**PARKING LOT EXPANSION ALLENTOWN CAT CLINIC**  
**MAJOR PLAN 2023-102**  
**ATTACHMENTS**

**SUBJECT: PARKING LOT EXPANSION ALLENTOWN CAT CLINIC  
MAJOR PLAN 2023-102  
REQUEST FOR PRELIMINARY/FINAL PLAN REVIEW**

SUBJECT: South Whitehall Township  
Allentown Cat Clinic  
Major Plan #2023-102  
Preliminary/Final Plan Review

Re: Parking Lot Expansion Allentown Cat Clinic  
Land Development #2023-102  
Review of Preliminary Final Plan  
SSM File 103400.0093

**SITE PLAN**

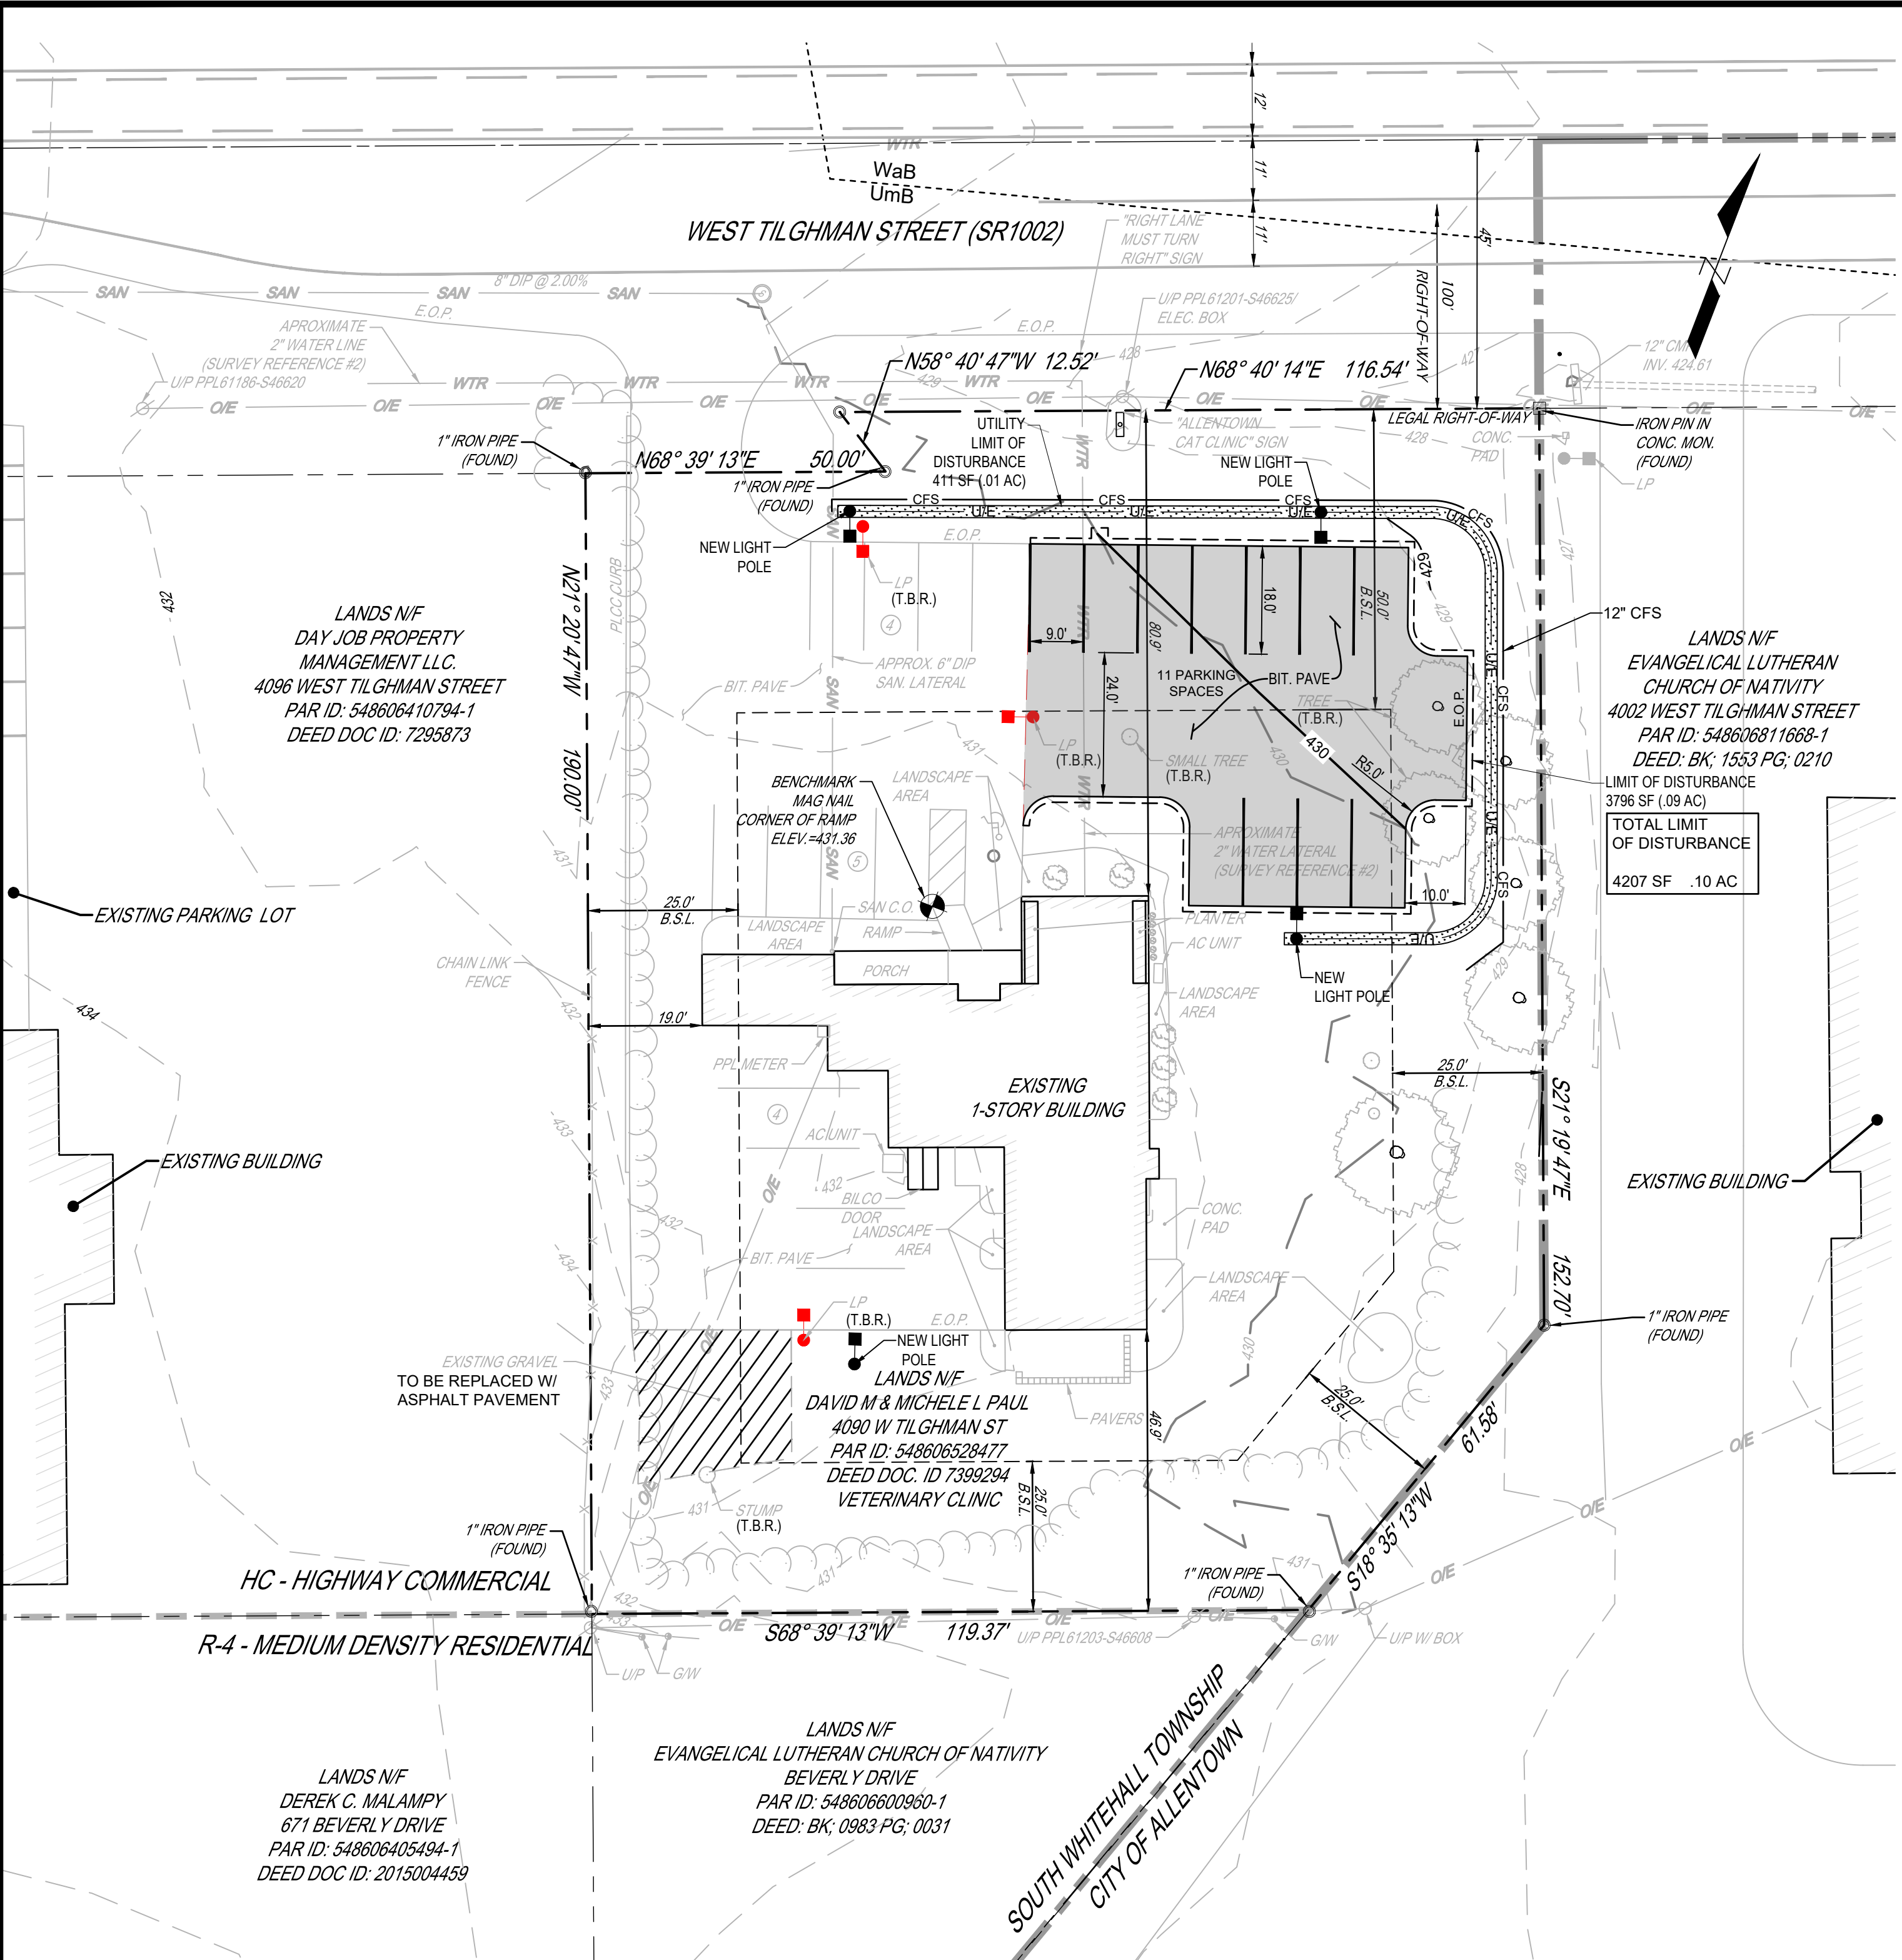
1. Property frontage improvements (as applicable) are required along West Tilghman Street, curb, sidewalk, shade trees, etc. (SALDO §312-26(a) §312-35(b), §312-40 pertain), and should be shown on the Plans. In the event waivers/deferrals/variances are granted, add a note to the Plan listing the ordinance sections and the date of approval. Additionally, a letter listing the requested waivers/deferrals/variances should be provided;

2. Provide Plans to PENNDOT for their determination of the adequacy of the existing driveway and the Highway Occupancy Permit (HOP). Appropriate signage for the driveway should be coordinated with PENNDOT and shown on the Plans;

7. Stormwater management facilities should be provided for the management of the increased impervious cover. If the project is exempt from the SMO based upon the standards in §296-17, a narrative should be provided to explain the reasons for the exemption while also showing that the runoff from the additional impervious cover will not affect any neighboring properties;

8. Identify available and required sight distances on the Plan for the driveway connection to West Tilghman Street, SALDO §312-12(b)(24) and §312-35(a)(6)(F);

9. Provide a sign tabulation for existing and proposed signage;
10. Provide vehicle turning templates for Fire, Trash, and Delivery, demonstrating the ability to enter and exit the site and maneuver throughout the site;

3. Site Plan Sheet 1 of 2 – Must show all water line on plans [South Whitehall Township water line/water lateral are not shown on plan.]
4. Due to the PennDOT project in comment 2, the Twp. will be relocating the water service in order to abandon the existing main along the south side of Tilghman St. This work will be incorporated with the PennDOT contract. This comment is for applicant information only.

5. Sanitary sewer private lateral should be located and marked. Maybe in conflict of light pole relocation.at driveway entrance.

1. Check calculations for impervious cover.
2. Please locate water service and curb box location prior to paving.
3. Please provide E&S plan.
